**A303 Amesbury to Berwick Down  
(Stonehenge) Wiltshire  
TR010025**

**Wiltshire Council (A303-AFP022)  
Written Summaries of Oral Submissions  
put at the Issue Specific Hearings held in  
August 2019**

Drawing Title: **DTA 2 COMPARISON**

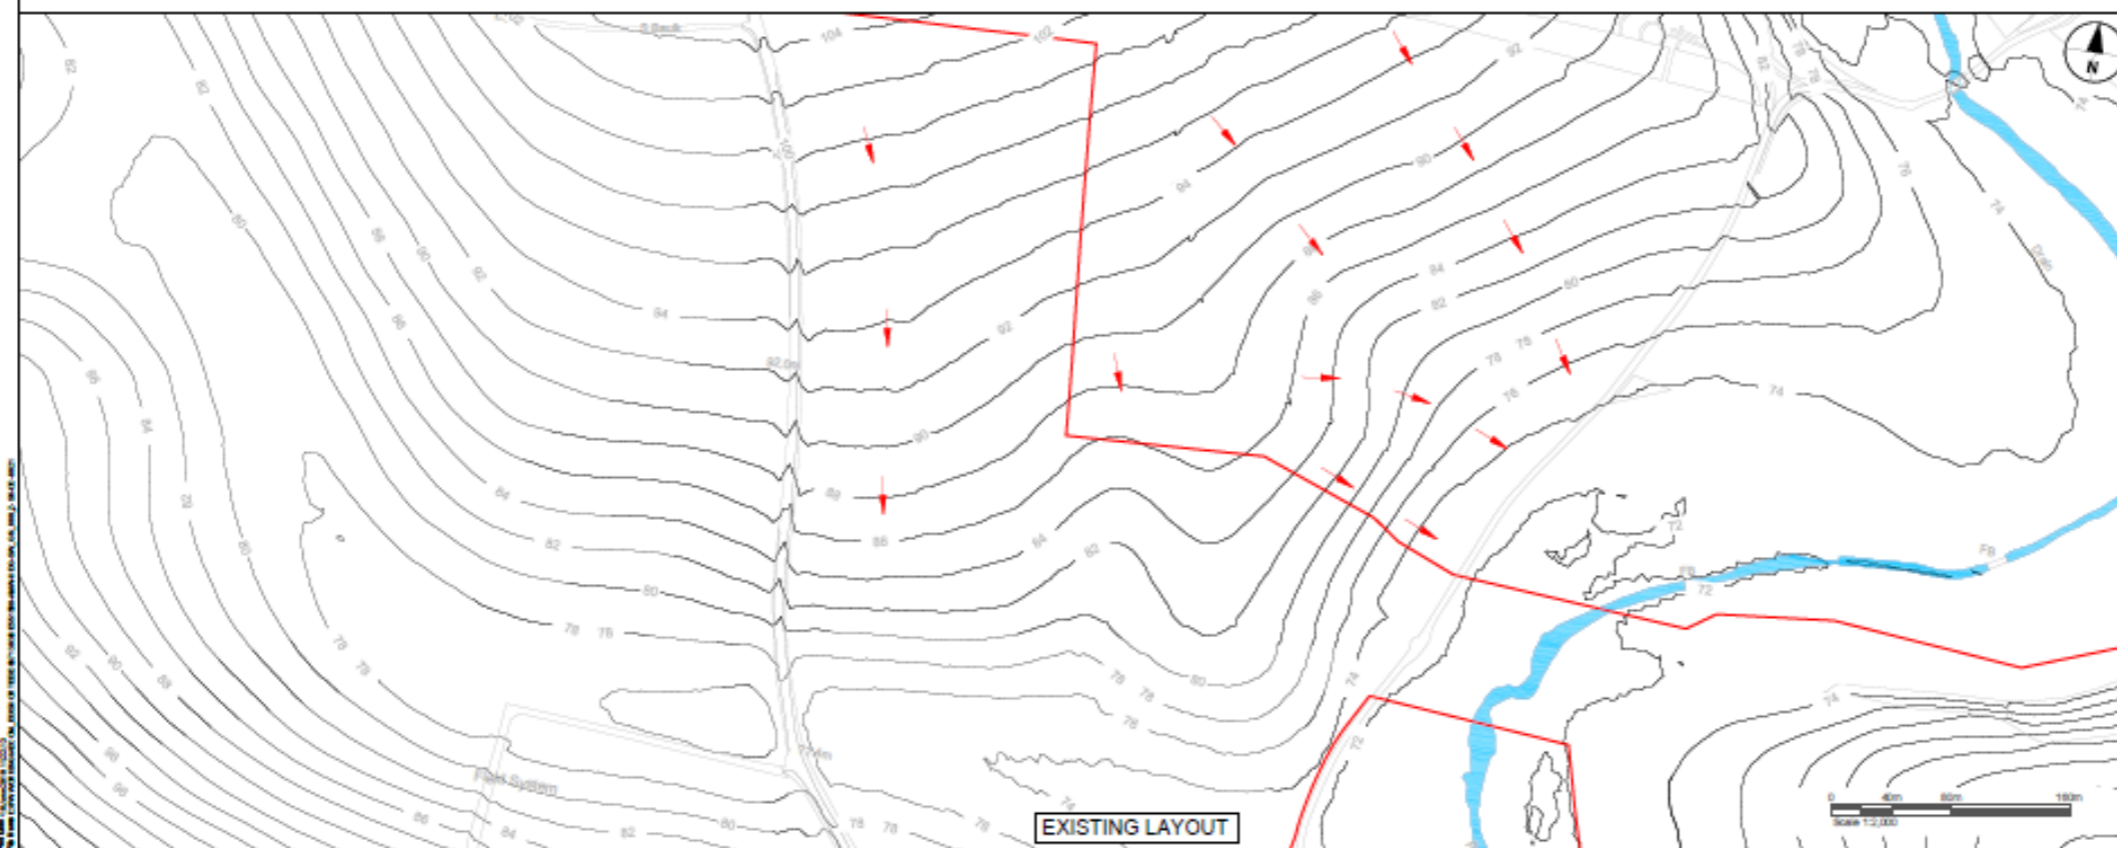
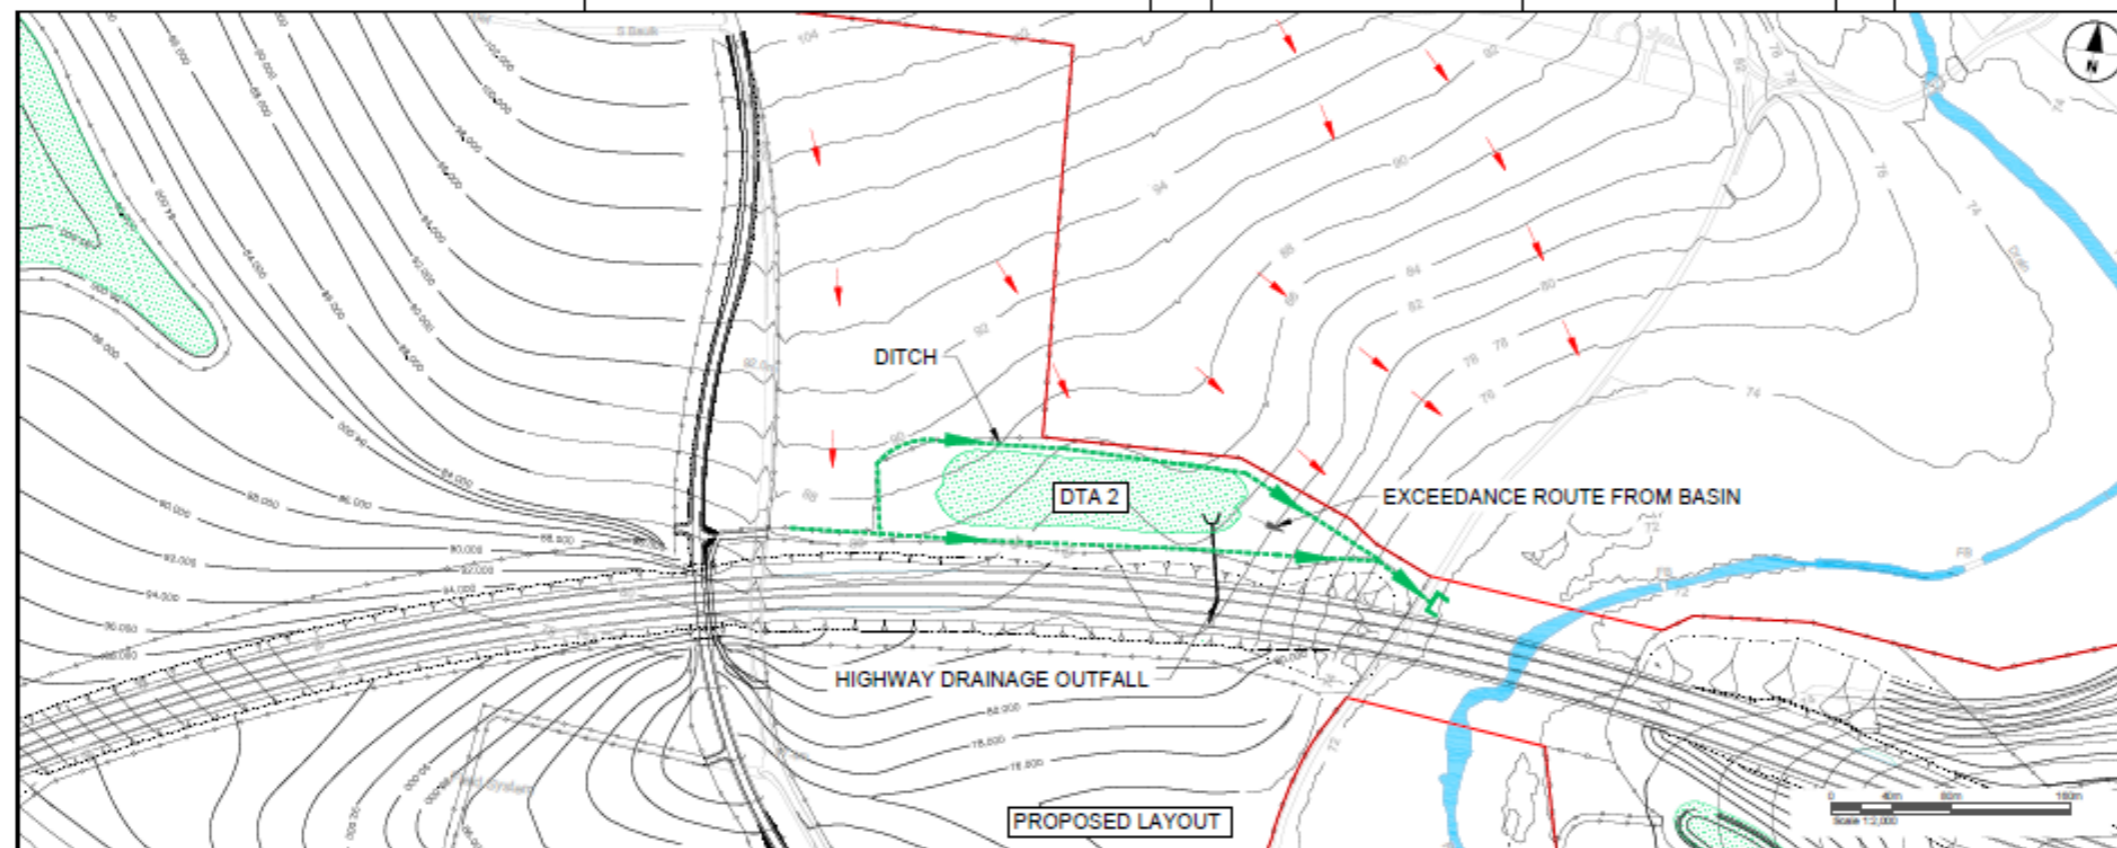
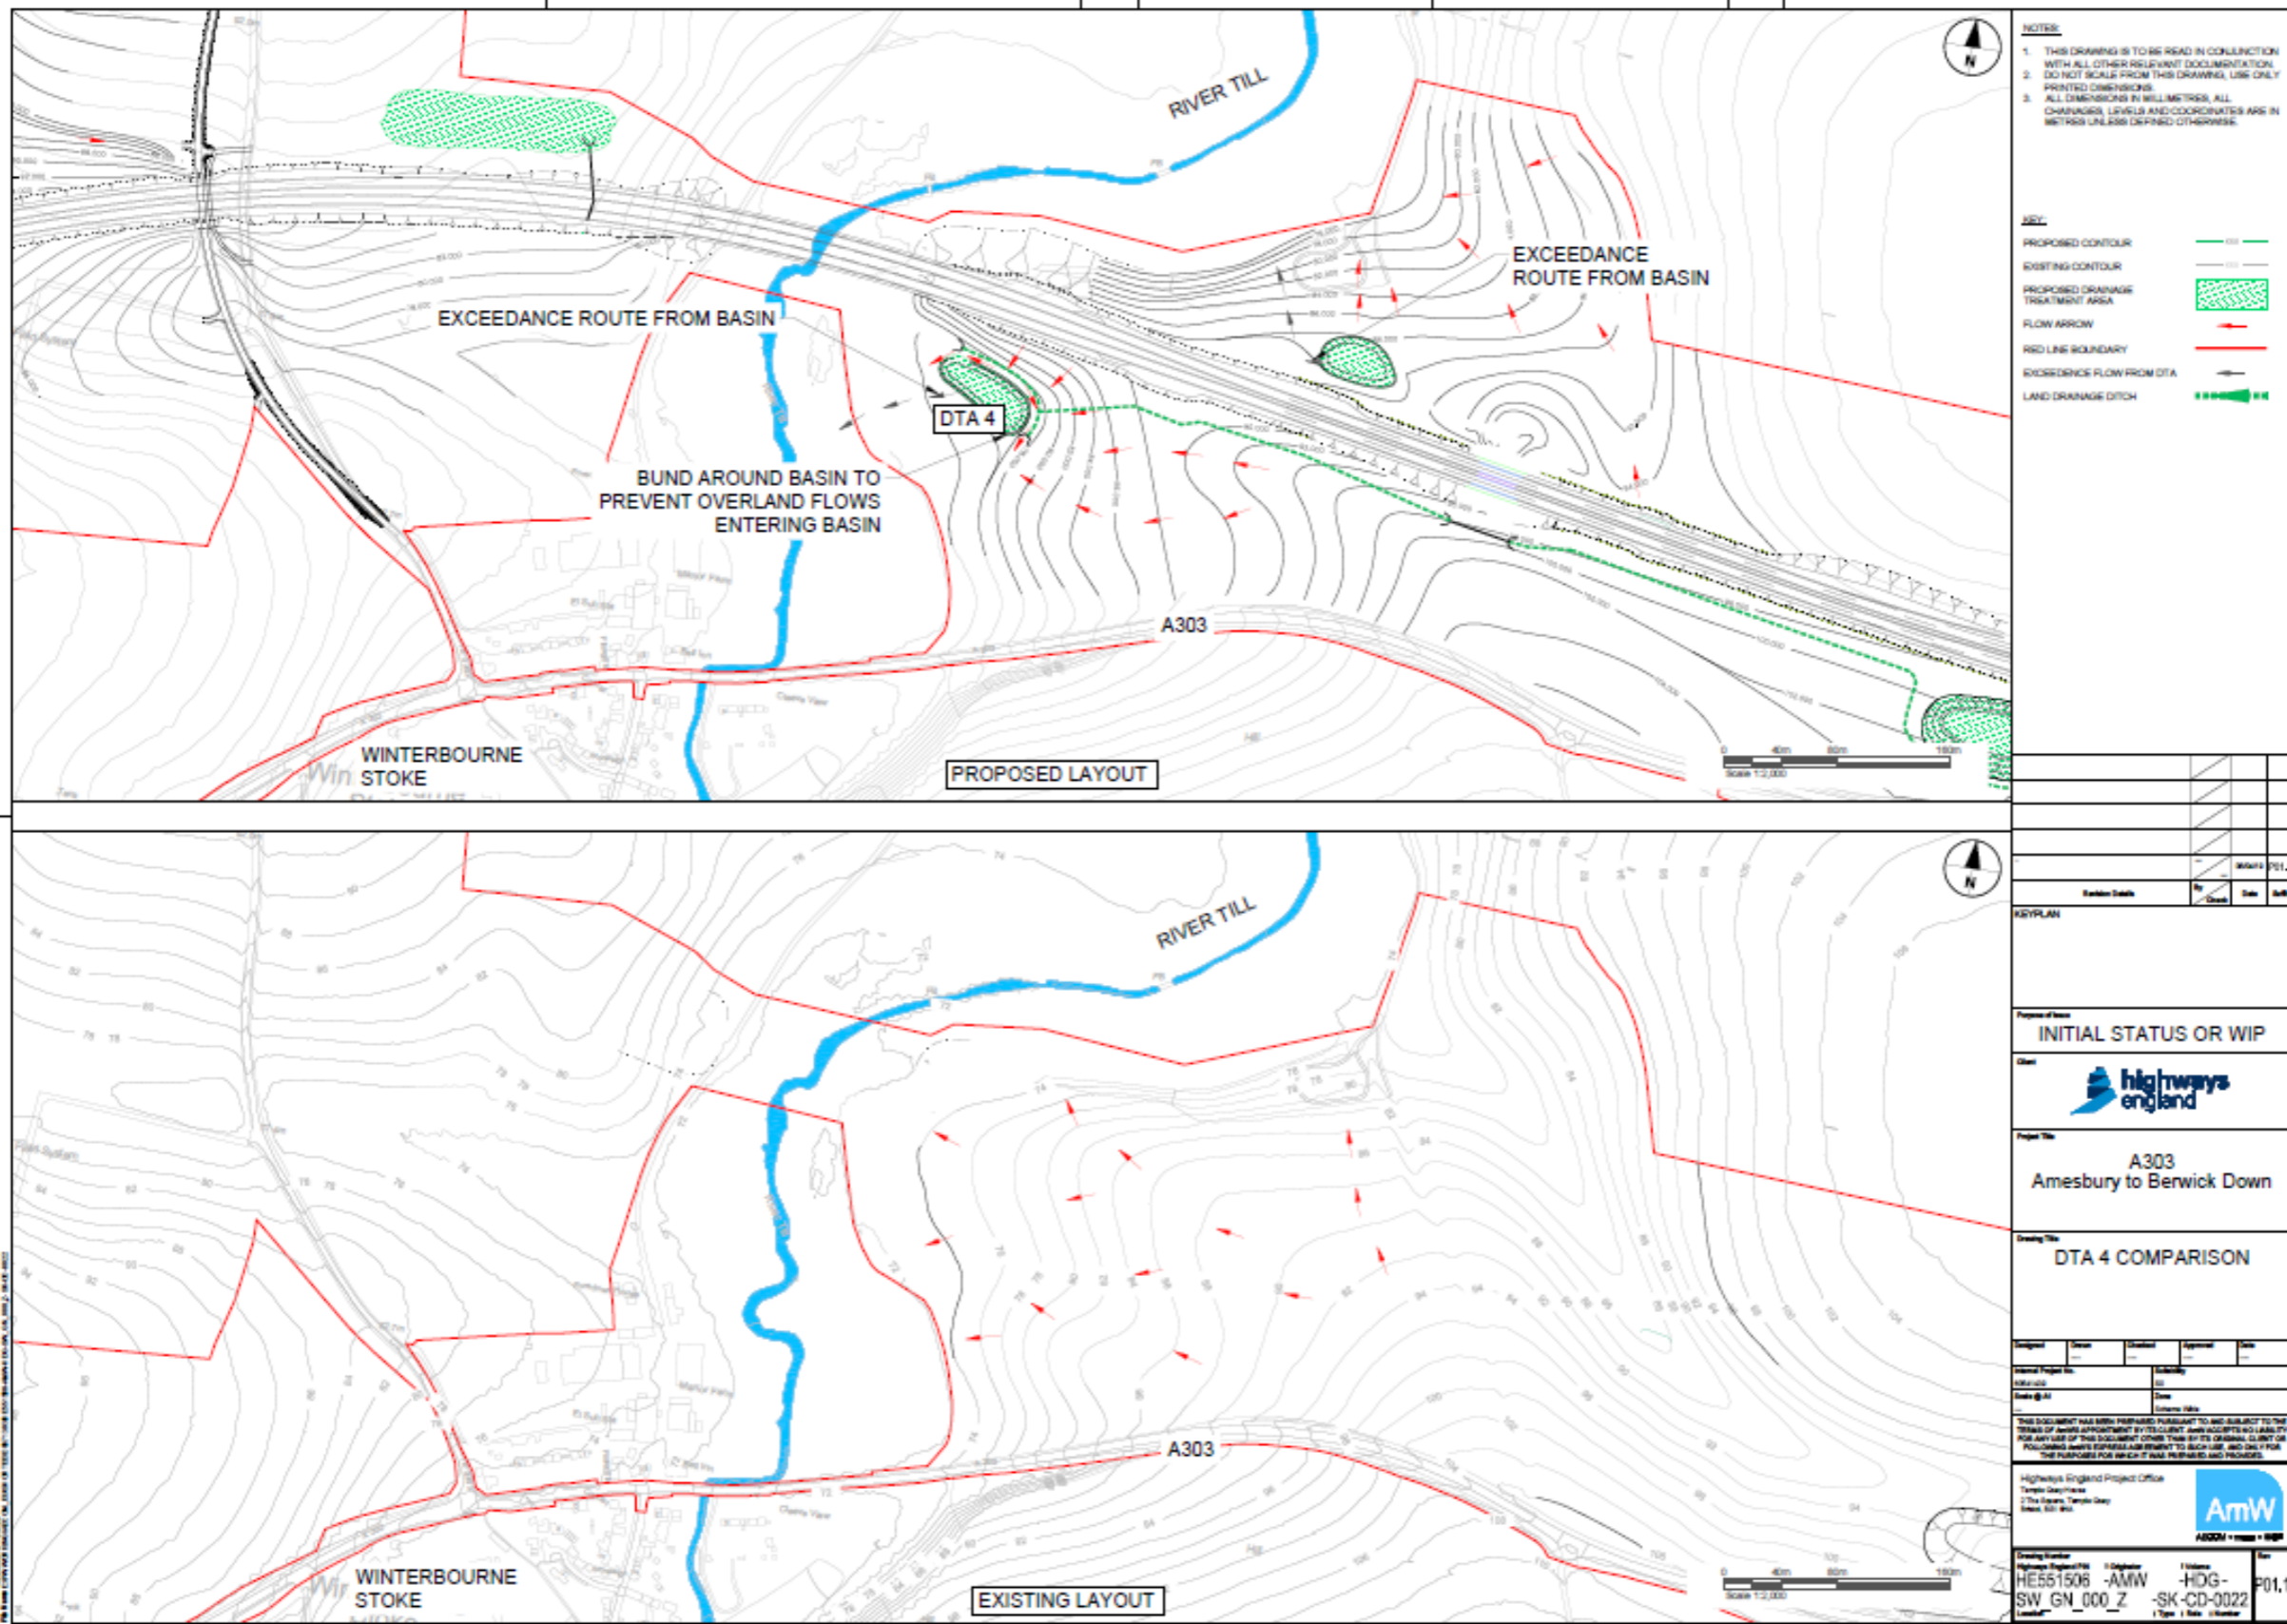
- The design is based on a 1 in 100 year+30% allowance for climate change with a 300mm freeboard being maintained.
- The drainage treatment areas capacity was tested against an upper end allowance of 40% for climate change, the remaining freeboard is more than 250mm at each drainage treatment area.
- To reduce the freeboard to zero the climate change allowance would have to be increased to between 66% and 84%, an increase of approximately 30% above the current upper end allowance of 40%.
- For the highway drainage to overtop the drainage treatment areas the design year return period would have to be greater than a 1 in 1000year return period storm.
- The exceedance routes had been created within the landscape that reflect existing topography to ensure surface flows would be directed to the current flow routes and would not be directed towards any sensitive receptors.

8.2 There is, therefore, enough capacity within the illustrative design of the road drainage treatment areas, to manage storm water runoff safely and the exceedance flow routes are not directed towards any sensitive receptors.
